CODE COMPLIANCE CERTIFICATE

Consent No: 100637

Building Work			
Building Consent No:	100637	Issued by:	Kāpiti Coast District Council
Project Description:	Stage 1 of 2; build implement shed with bedroom/ensuite, and a separate studio/kitchen with living accommodation including bedroom, bathroom.

STAGE ONE: BEDROOM-STUDIO IMPLEMENT SHED- WORKSHOP FOR PAETAUA TRUST

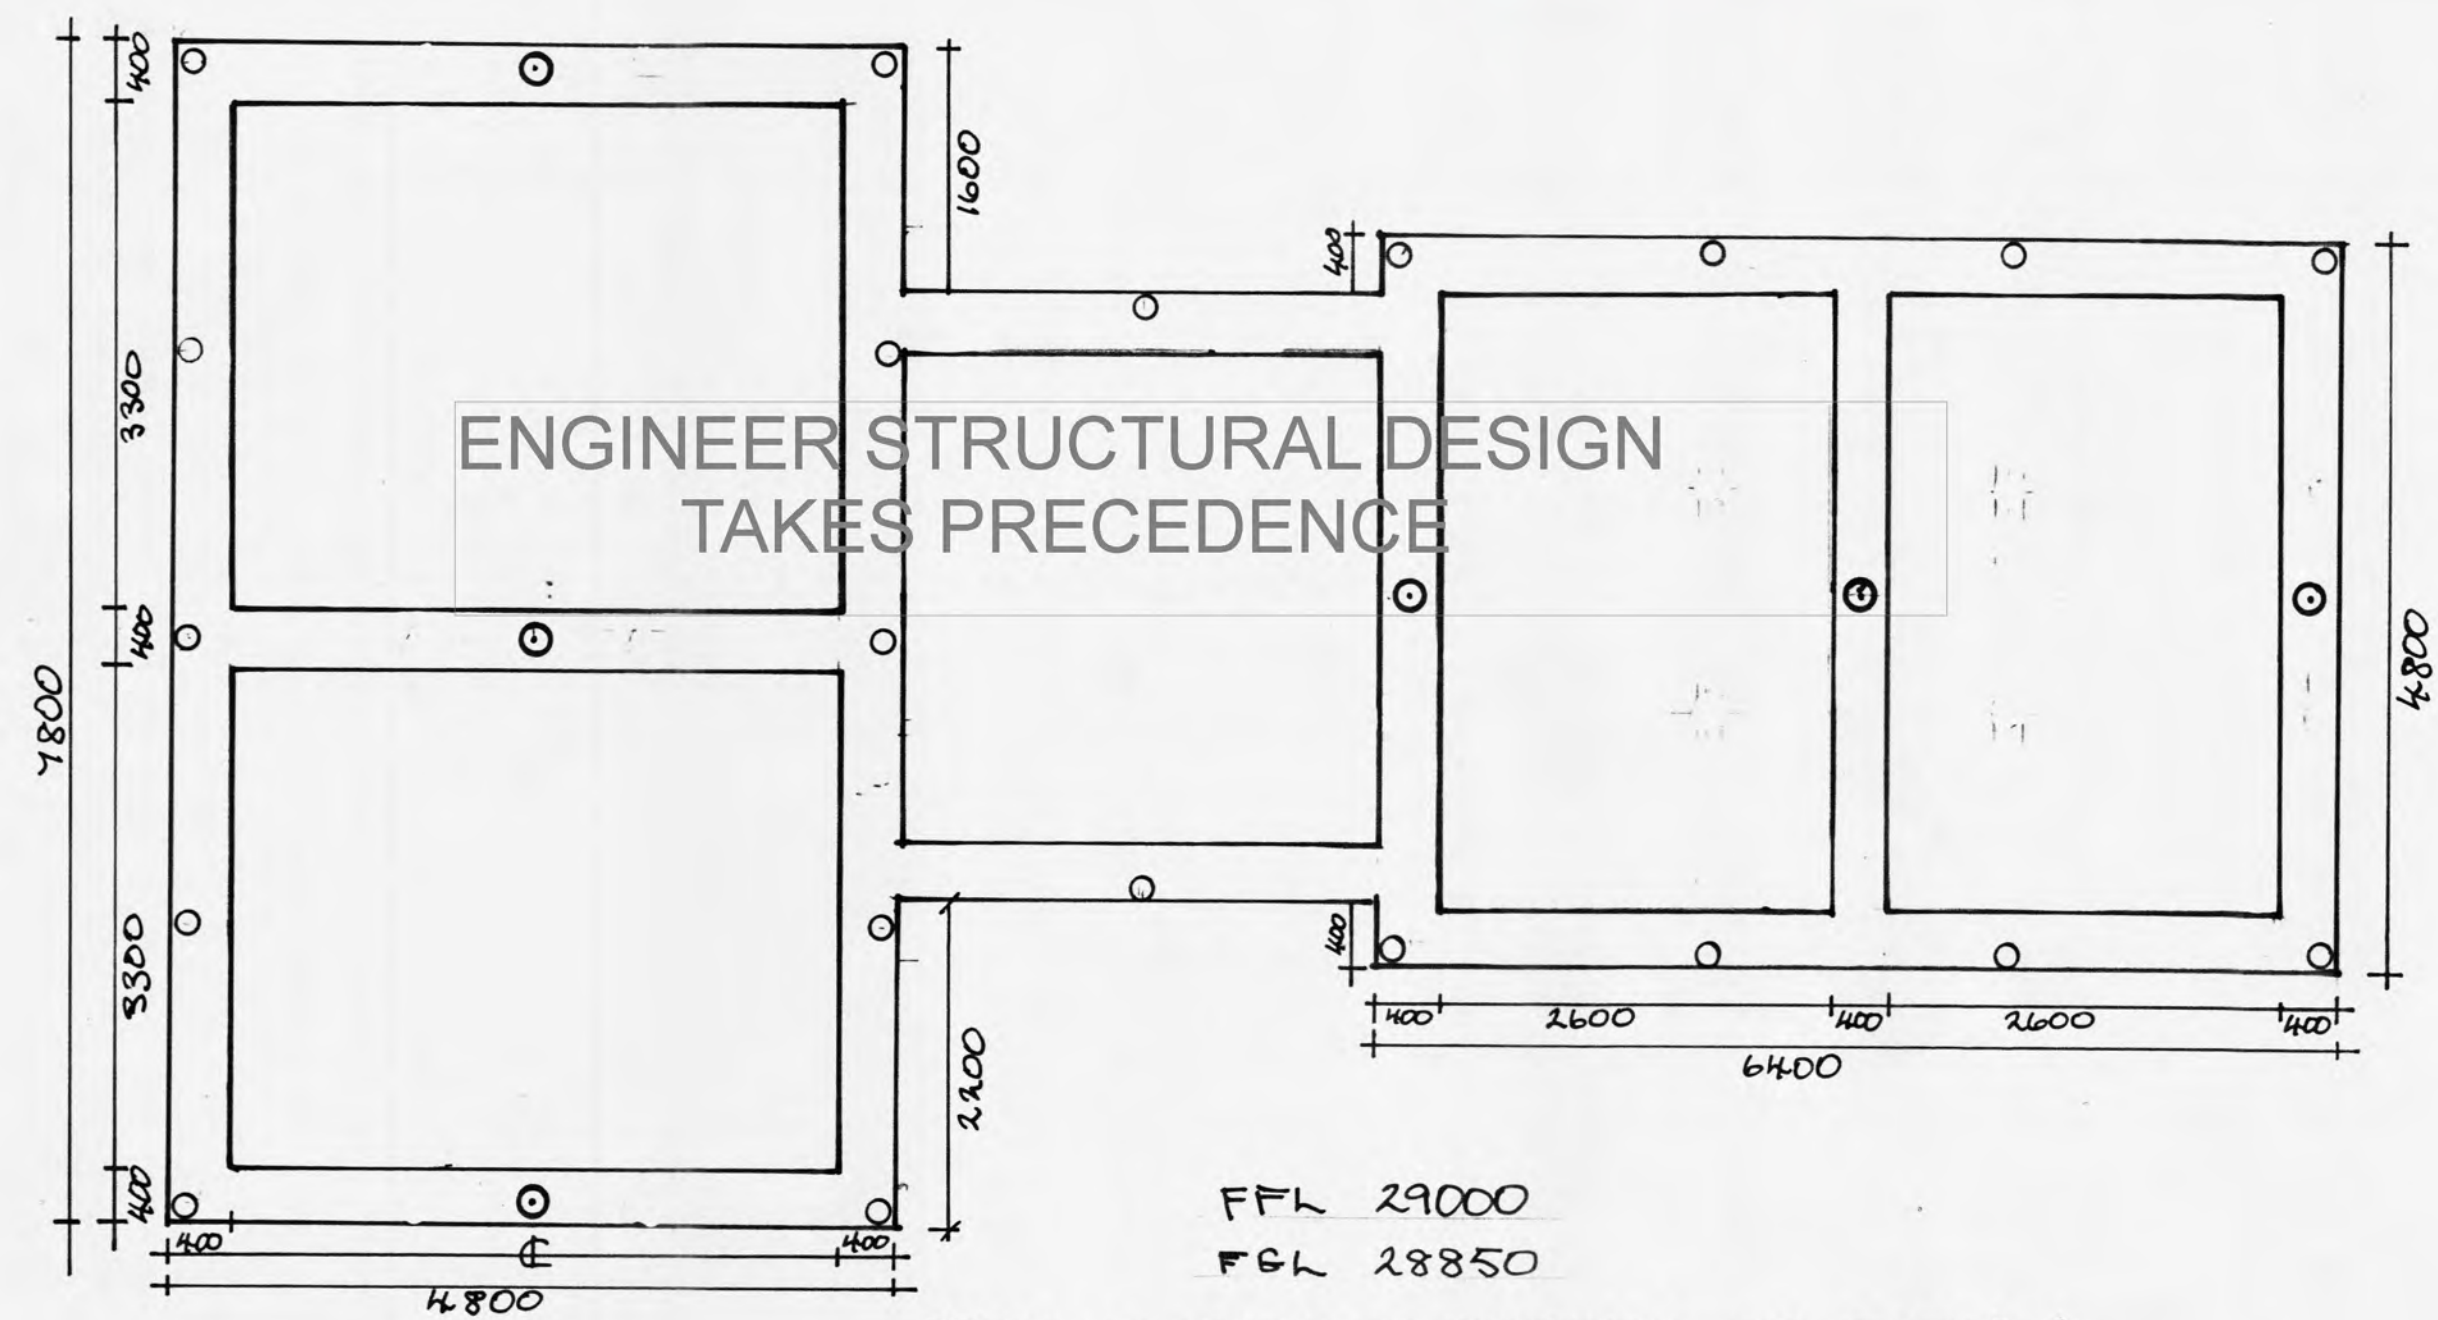
SUPERCEDED - REFER TO FRAMETEK DRAWINGS

ROOF PLAN

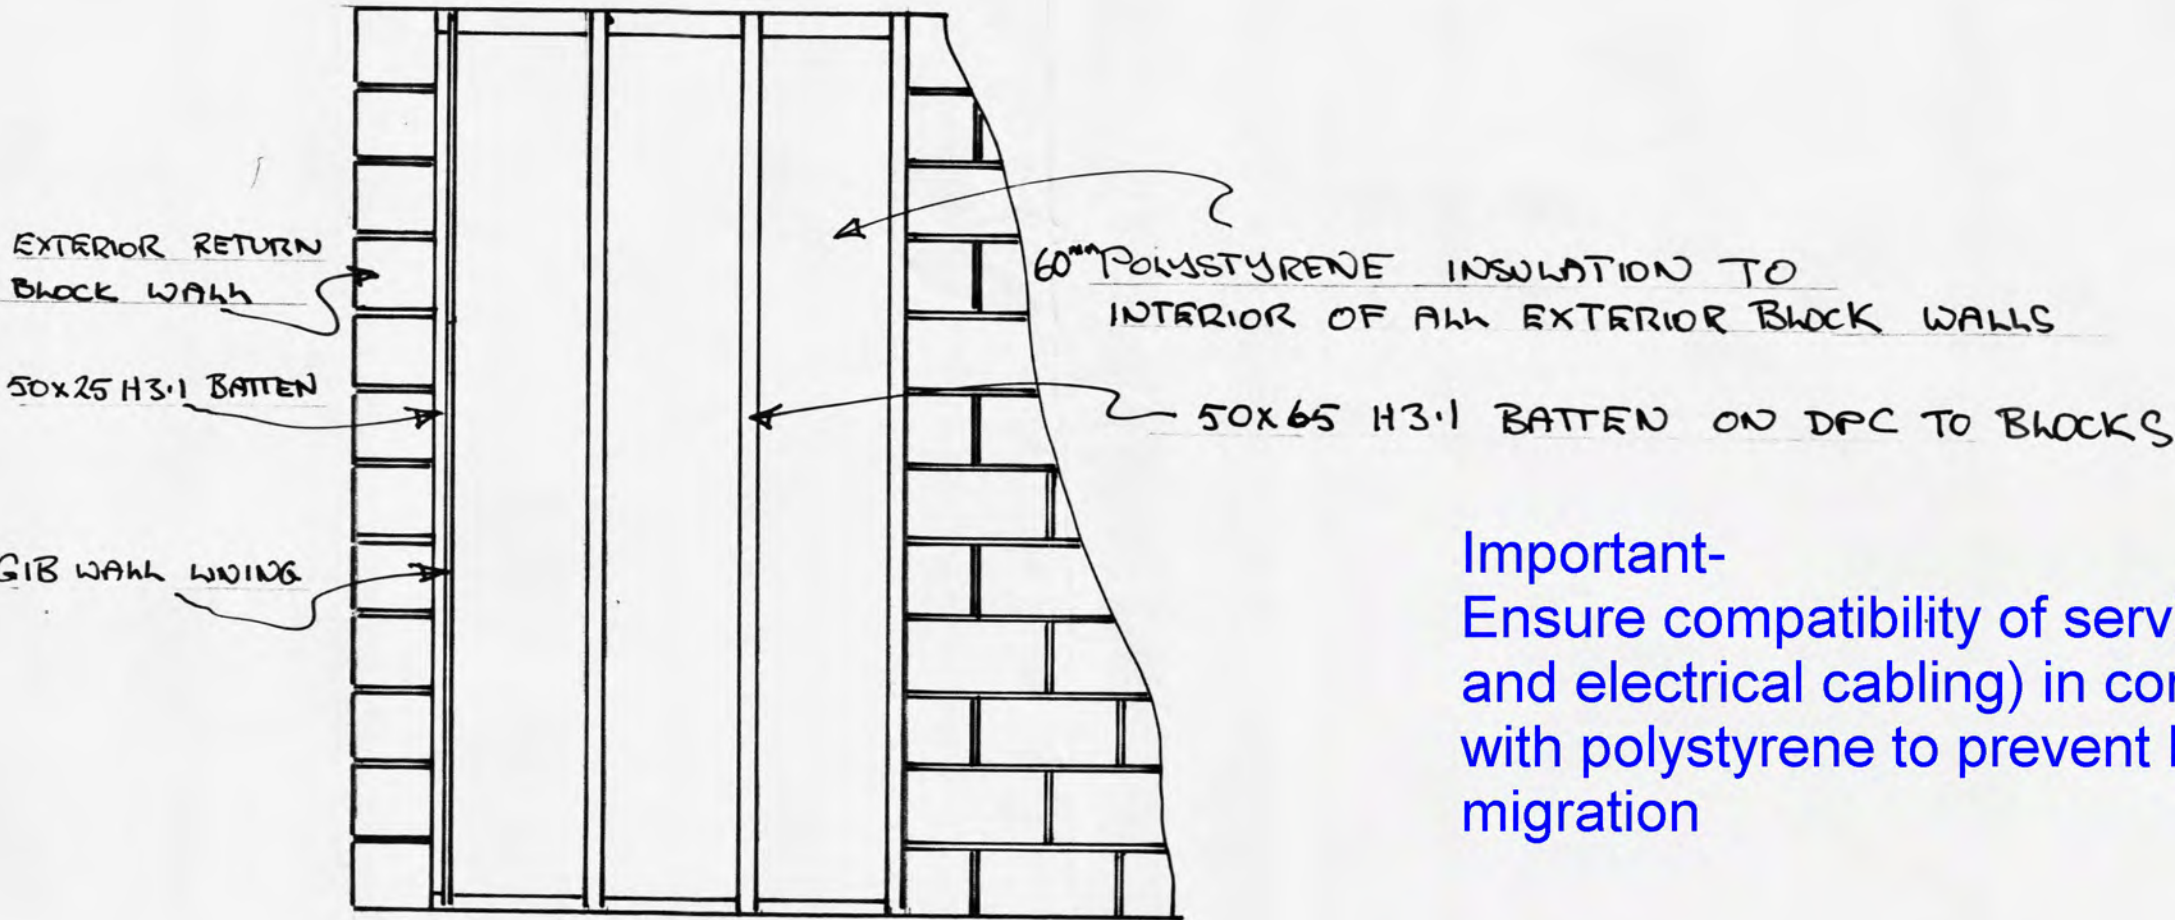
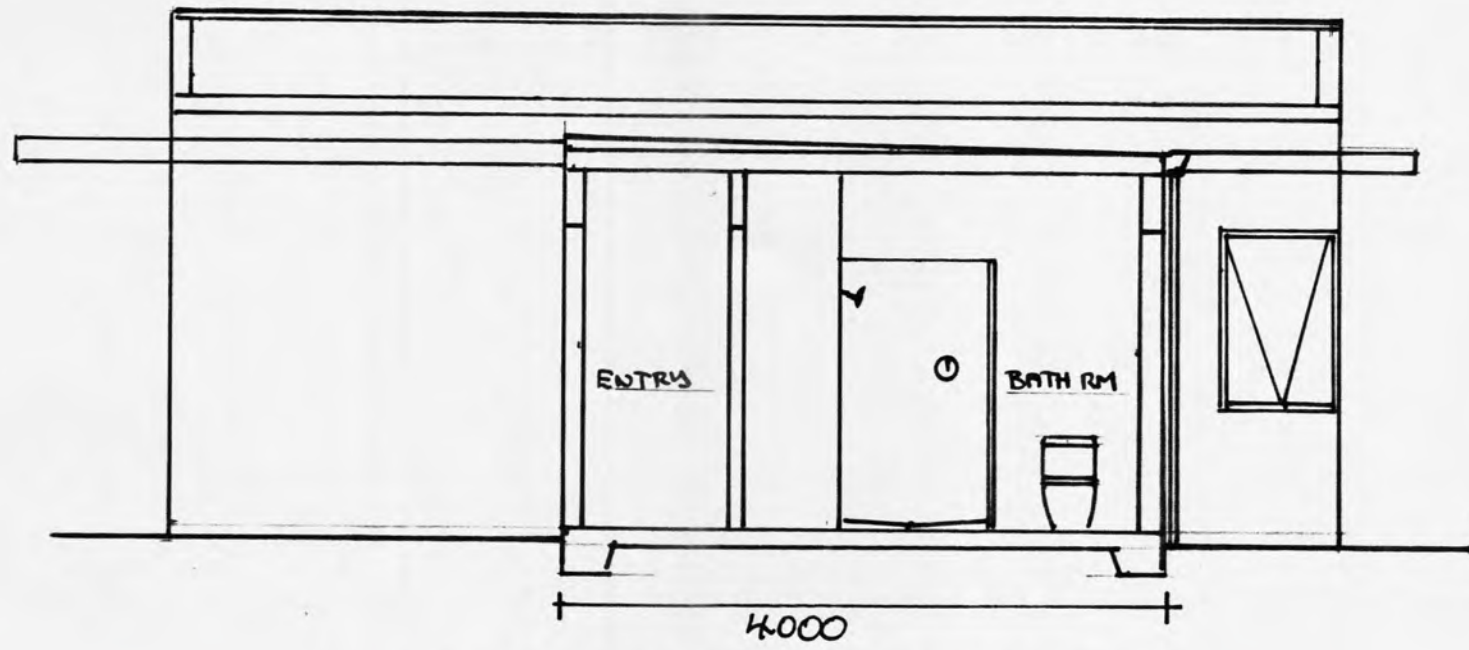
Downpipes discharging on to a lower roof require a spreader E2/AS1 clause 8.1.6

TYPICAL EXTERIOR WALL DETAIL SHOWING STRAPPING TO BLOCKWORK AND POLYSTYRENE INSULATION

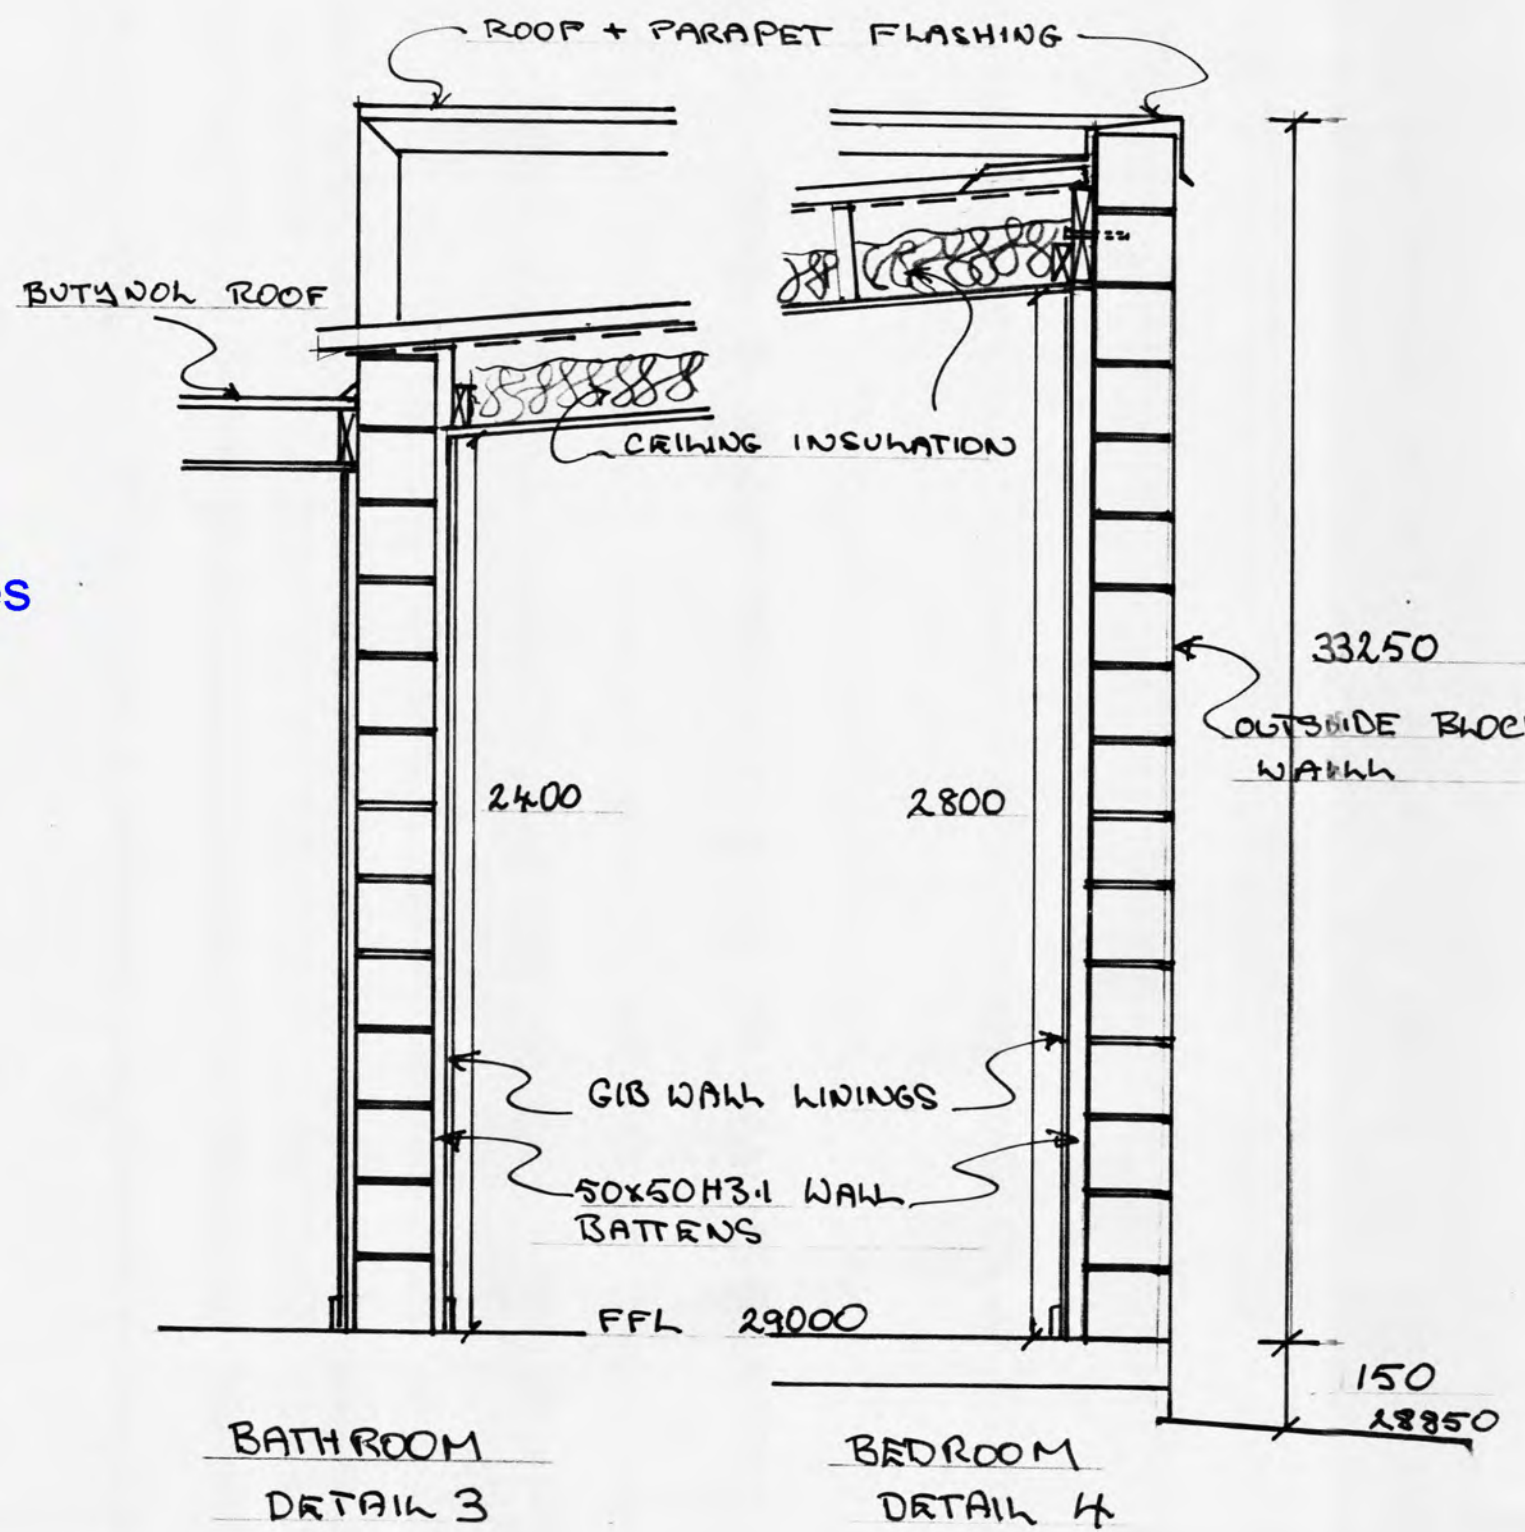
Important- Ensure compatibility of services (pipes and electrical cabling) in contact with polystyrene to prevent PVC migration

Check the potability of the water supply on a regular basis.

WATER STORAGE TANK NEED TO BE CLEANED OUT ON A REGULAR BASIS

Some secondary water treatment may be required
